AGENDA

Historic District Commission Meeting

7:00 PM - Tuesday, September 12, 2023
Council Chambers

HDC Work Permit Staff Review

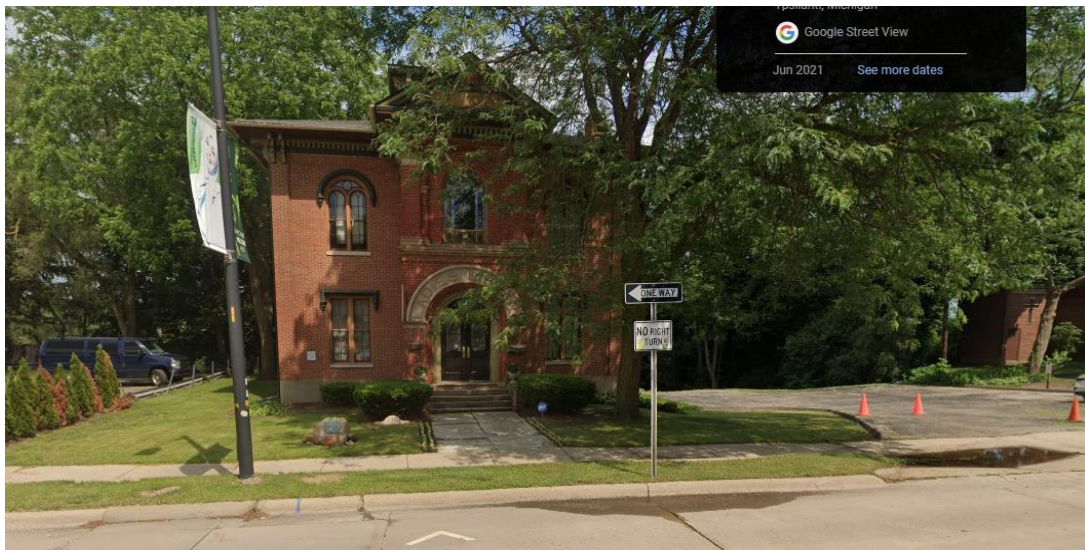
It is true that the proposed fence around the front yard would change the spatial relationship the house has with the street, but staff doesn't think that spatial relationship would be destroyed, as per the Standards. To staff, the proposed fence's transparency and height (4') mitigate some of the negative effects of erecting a barrier between the house and the street. Staff finds that this proposed 4-foot fence would not destroy historic materials, features, and spatial relationships that characterize the property, and that this fence would be compatible with this site's historic materials, features, size, scale and proportion, and massing to protect the integrity of the property and its environment, meeting Secretary of the Interior's Standard for Rehabilitation 9. Standard 10 states that related new construction will be able to be removed in the future without negatively impacting the essential form and integrity of the historic property and its environment, and the proposed fencing meets this Standard as well.

The proposed fence along the front lot line would also define the front line of the current parking area. Old photos and postcards seem to show that this portion of the site was historically relegated to utilitarian uses and buildings like garages and/or carriage barns. The current expanse of paving for a large parking lot seems to staff to reinforce a commercial sense of the property. Mr. Winters expressed at the August 22 commission meeting that he wants to make the site feel more residential and he described wanting to landscape some of the current parking lot to help achieve that goal. Staff thinks that having the 4-foot, mostly transparent metal fence along this area of the property at the sidewalk also meets the design guidelines and Standards, and if cars could be parked more toward the rear of the lot with shrubs and landscaping more toward the sidewalk, the fence's visual effect on the historic site and materials would be further minimized. (Note: If some of the asphalt in the current parking lot gets removed and the parking area is reduced, it is possible that a new site review and additional site work will be needed for zoning compliance; applicant is aware of this and will work with city planning staff as needed.)

June 2021 image of 130 N Huron from Google streetview.

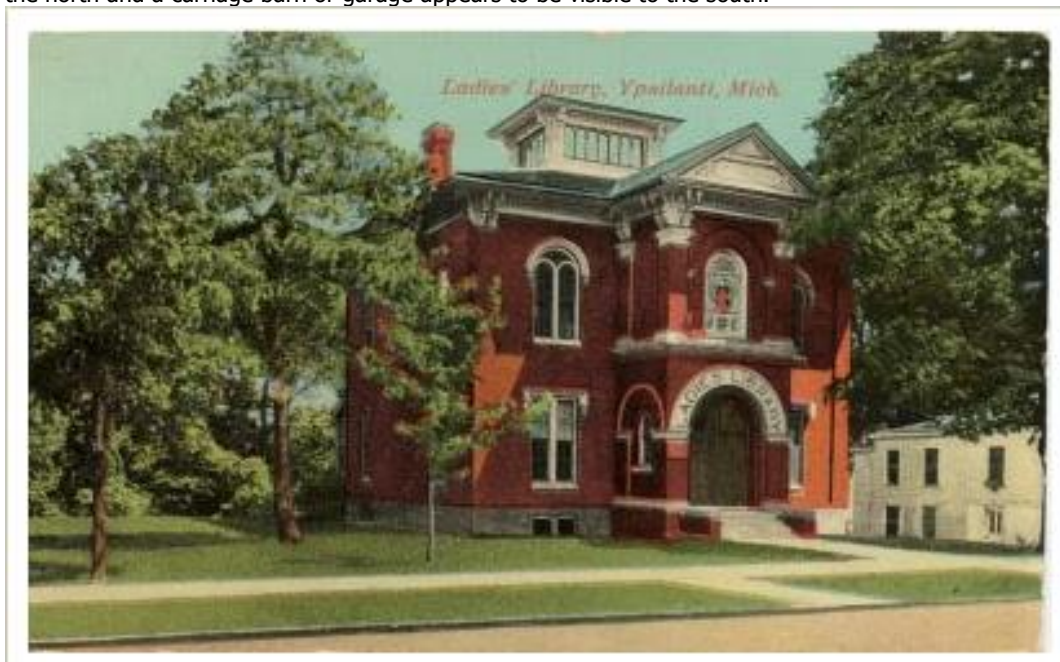
Undated image from a negative in the Ypsilanti Historical Society's photo archives. Shrubs are visible to the north and a carriage barn or garage appears to be visible to the south.

DATE 08/22/2023	THE DESIGN FACTORY ANN ARBOR, MI 48103	NORTH RIVER ST. PORCH 627 N. RIVER STREET YPSILANTI, MICHIGAN 48198	DESIGN REVIEW 06/23/23	REVISIONS	BY
SCALE AS NOTED					
DRAWN MTJ					
JOB# 23-0080					
A11-a

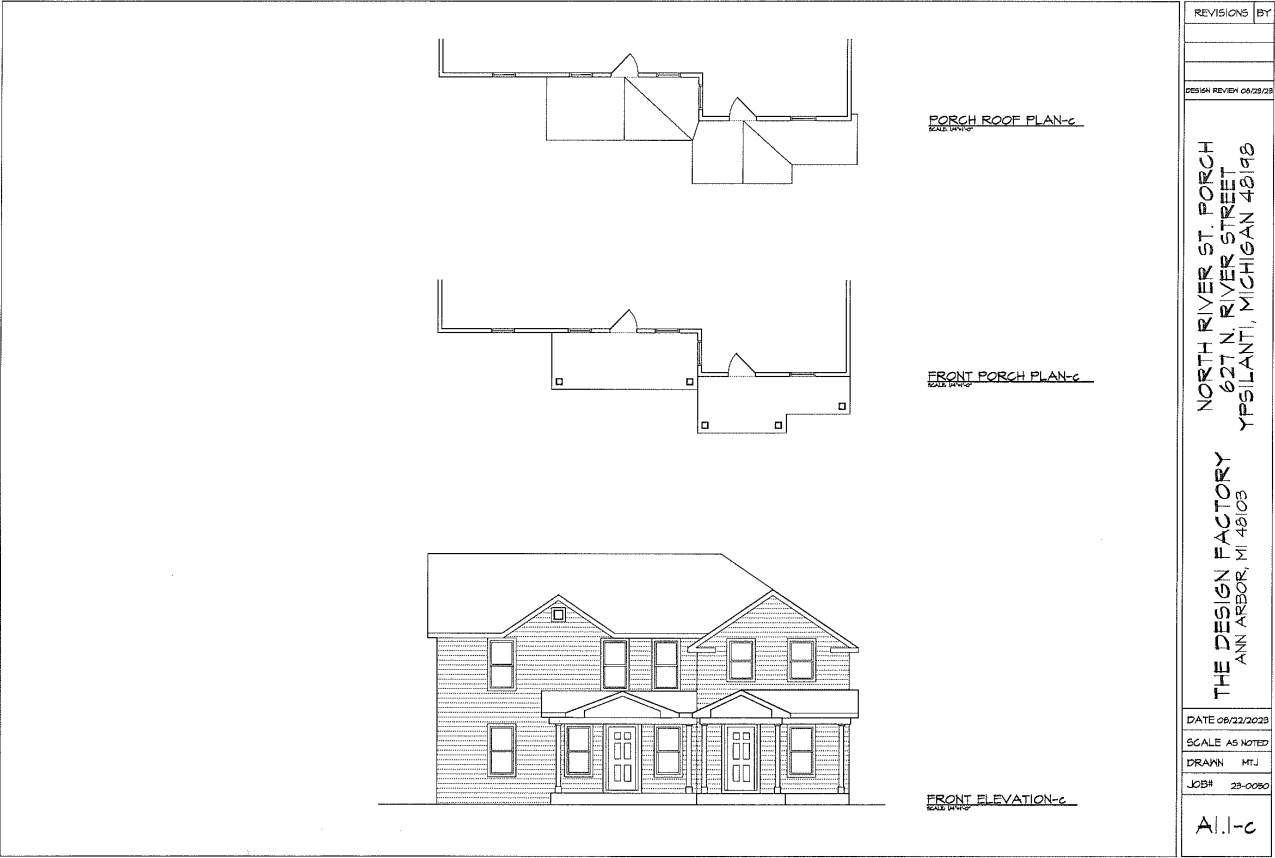
- removing siding,
- installing a vapor barrier,
- installing cedar lap siding in 6-8" exposure on the front (east)
- installing smooth fiber cement lap siding in 6-8" exposure on the sides and rear (north, south, and west).
- In addition, added to this amendment are plans/proposals for the porch roofs for the concrete porches that were approved in April. There are four possibilities presented. Applicant would like to know which option the commission would most prefer. Staff believes that applicant prefers option B, but that should be clarified at the meeting.

Materials: painted wood supports (would the porch materials be painted wood? Plans don't indicate materials), roof shingles to match roofing on main body of house, vapor barrier, cedar siding in 6-8" reveal on front and smooth fiber cement lap siding in 6-8" reveal for rear and sides.

- e. Option C seems to staff to be closest to what was there most recently, but it doesn't try to restore any appearance of the former historic roof across the front of the wing. Staff thinks that is a bit of a missed opportunity.

siding has a smooth finish, and that all historic trim will be preserved or replicated as necessary, and that the historic trim and the new siding will fit together and appear as it did historically. Also approved is proposed porch option __ [with the conditions that... could include the components of the porch will be painted wood, railing of a height to the bottom of the windows will be included and will meet the porch design guidelines in the city's porch fact sheet/railing won't be included, other conditions commission deems appropriate.] The proposed work meets the Secretary of the Interior's Standards for Rehabilitation 6 and 9.
